BEFORE THE ENVIRONMENTAL QUALITY COUNCIL
STATE OF WYOMING

In the Matter of:)
Basin Electric Power Cooperative) Docket No. 10-2802
Air Quality Permit No. MD-6047)
BART Permit: Laramie River Station)

**IN THE MATTER OF A PERMIT APPLICATION (AP-6047) FROM BASIN ELECTRIC
POWER COOPERATIVE FOR A BEST AVAILABLE RETROFIT TECHNOLOGY (BART)
PERMIT FOR THE LARAMIE RIVER STATION**

DECISION

VISIBILITY MODELING RESULTS (Baseline vs. LNB and SCR)

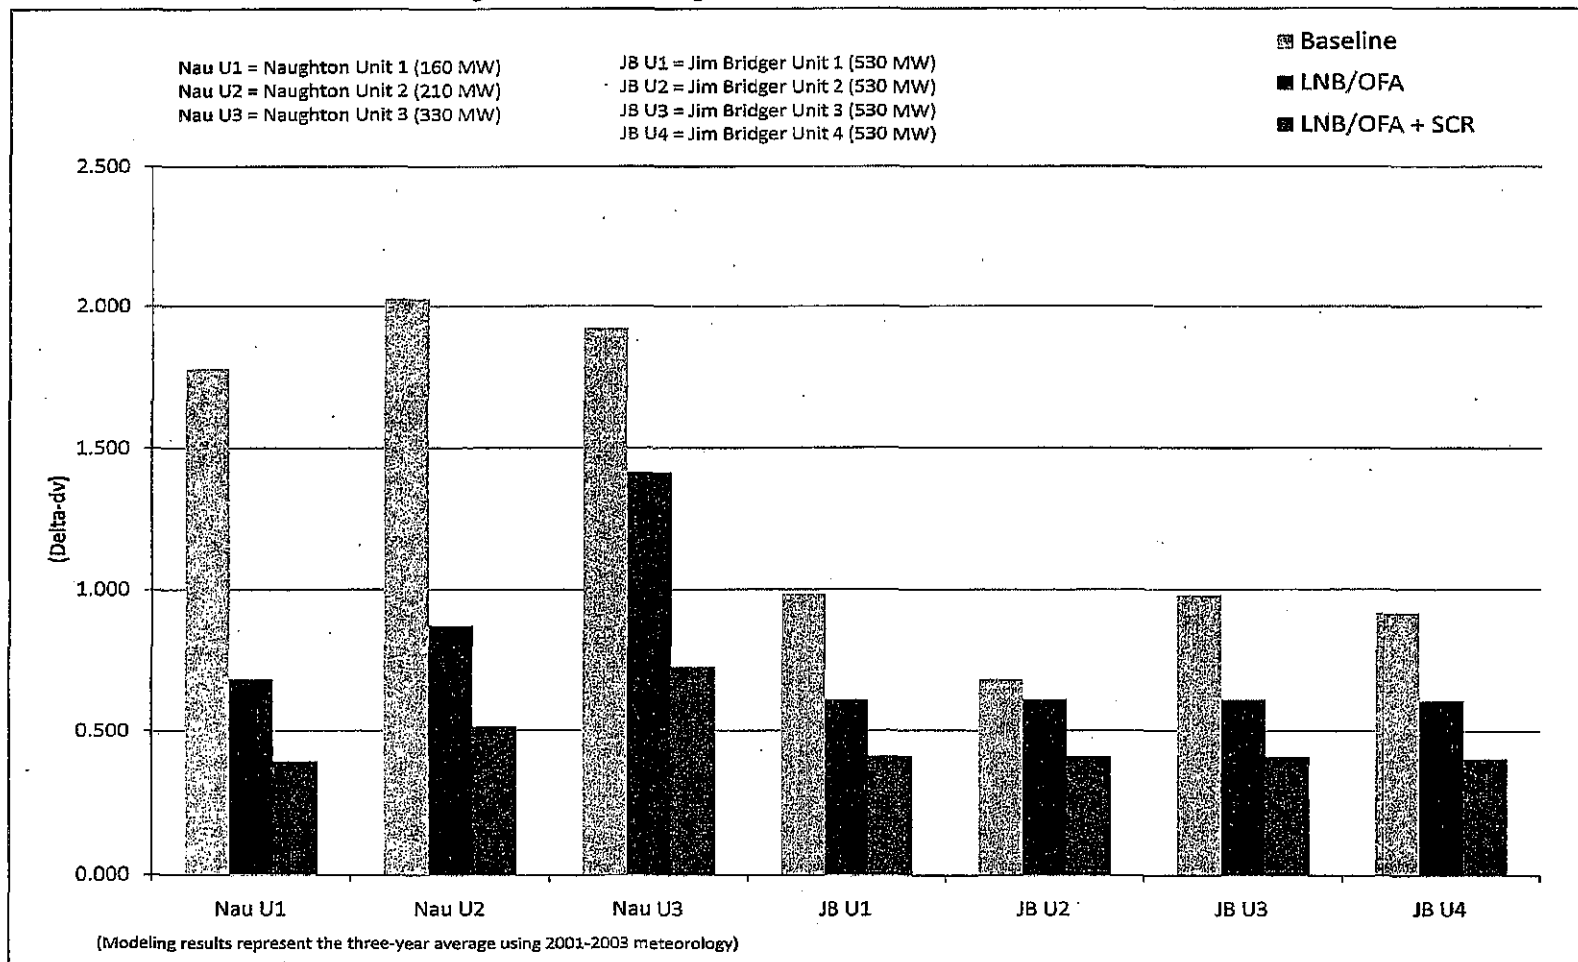
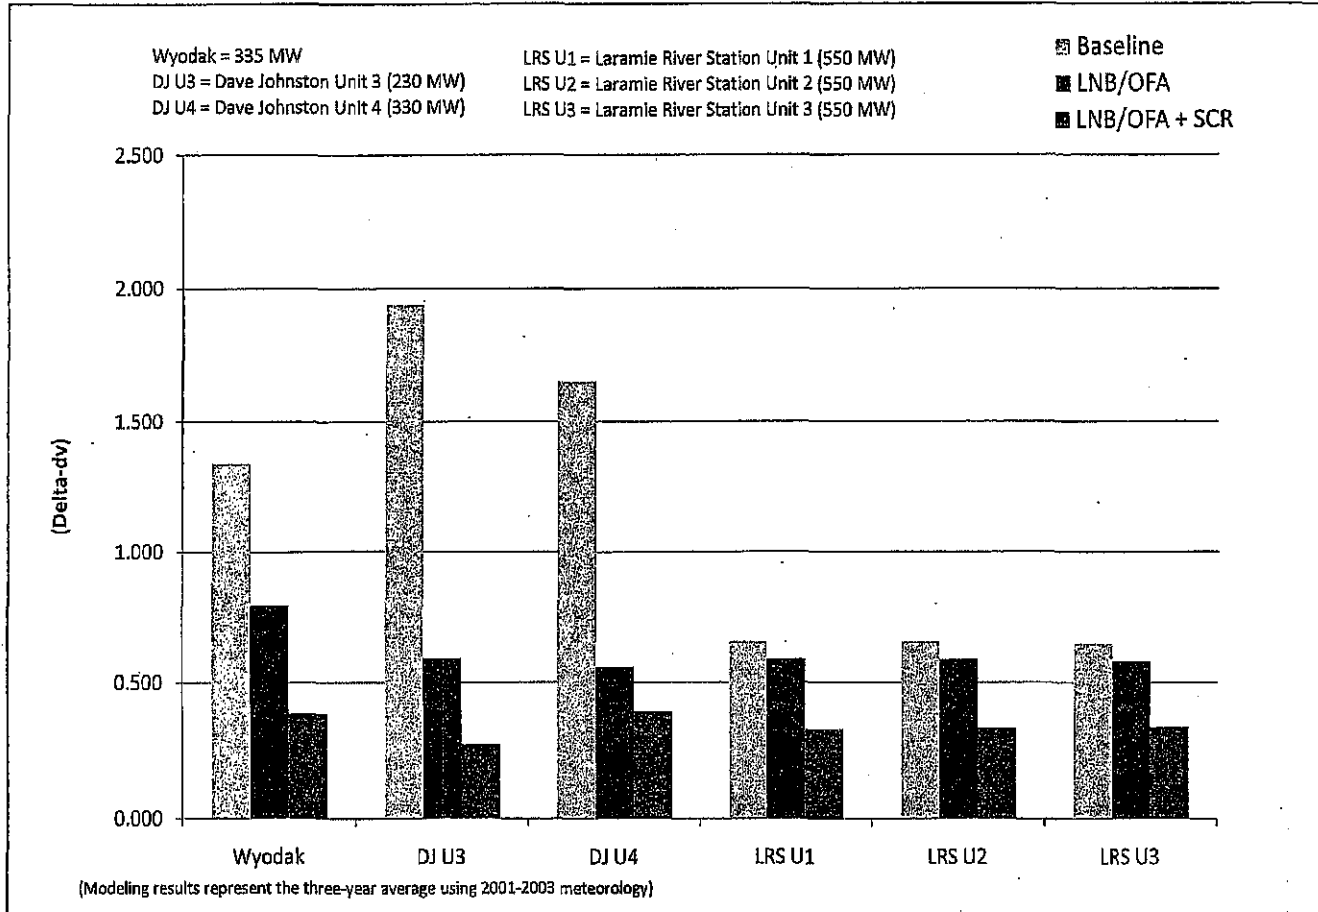
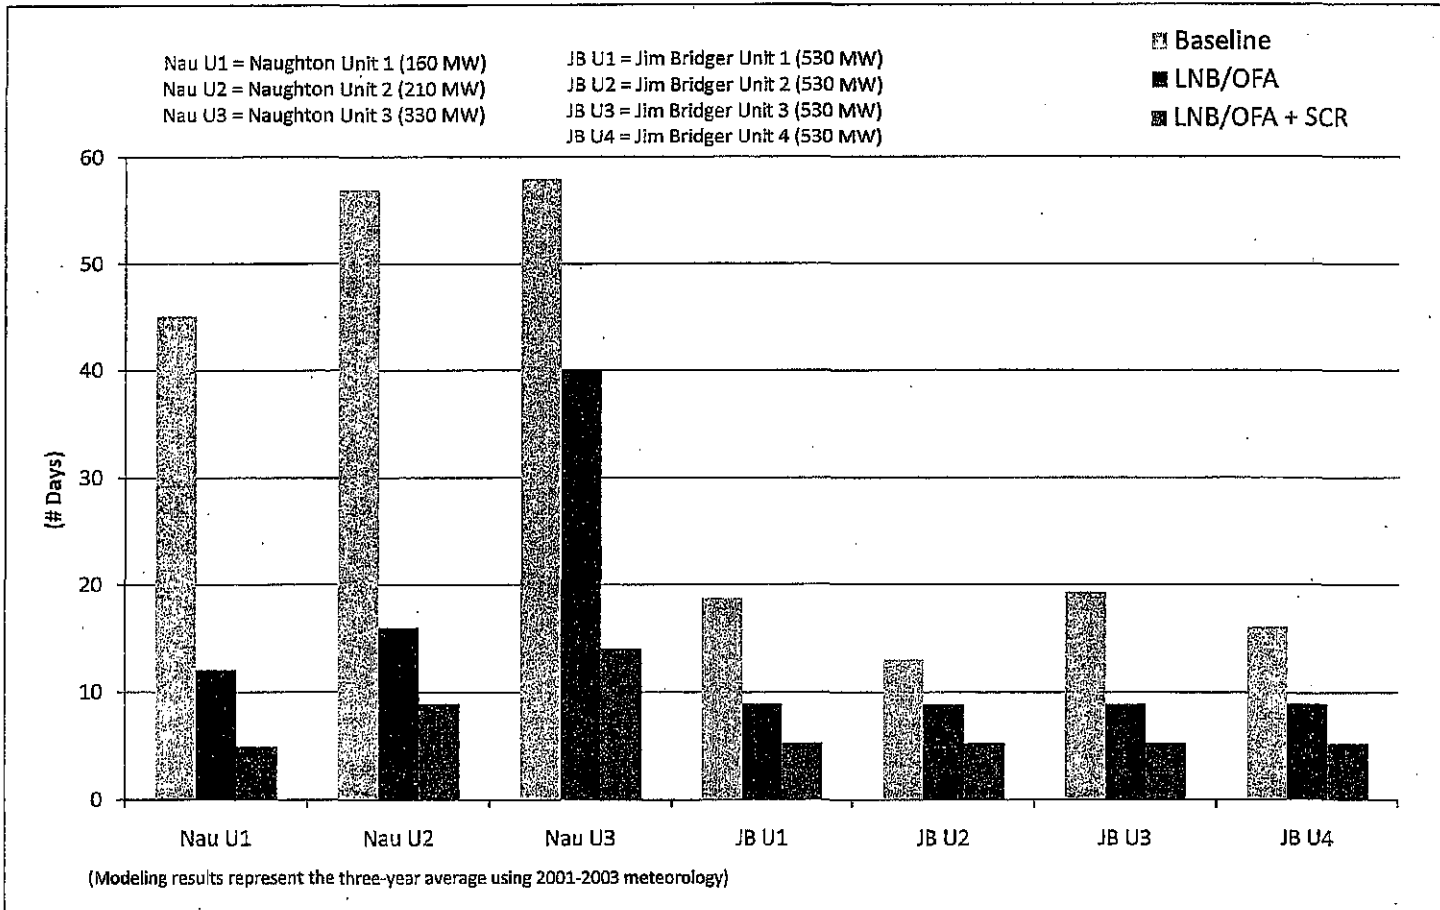
- IV.5 **General Comments: Visibility Improvement** – PacifiCorp commented that a BART determination that only relied on the 98th percentile, three-year average results from CALPUFF may be too narrow to satisfy Appendix Y.

Response – The Division did not rely solely on the three-year average of the 98th percentile CALPUFF results to evaluate the expected visibility changes for the BART control options. The 98th percentile values and the number of days with predicted results above 0.5 dv were presented in the Division's BART analyses for each of three modeled years, for each Class I area, and for each control option. The three-year average of the 98th percentile results and the number of days above 0.5 dv were chosen for graphical representation and were mentioned prominently in the Division's conclusions because they offered the clearest comparison of one control option to another (see graphs in Appendix A).
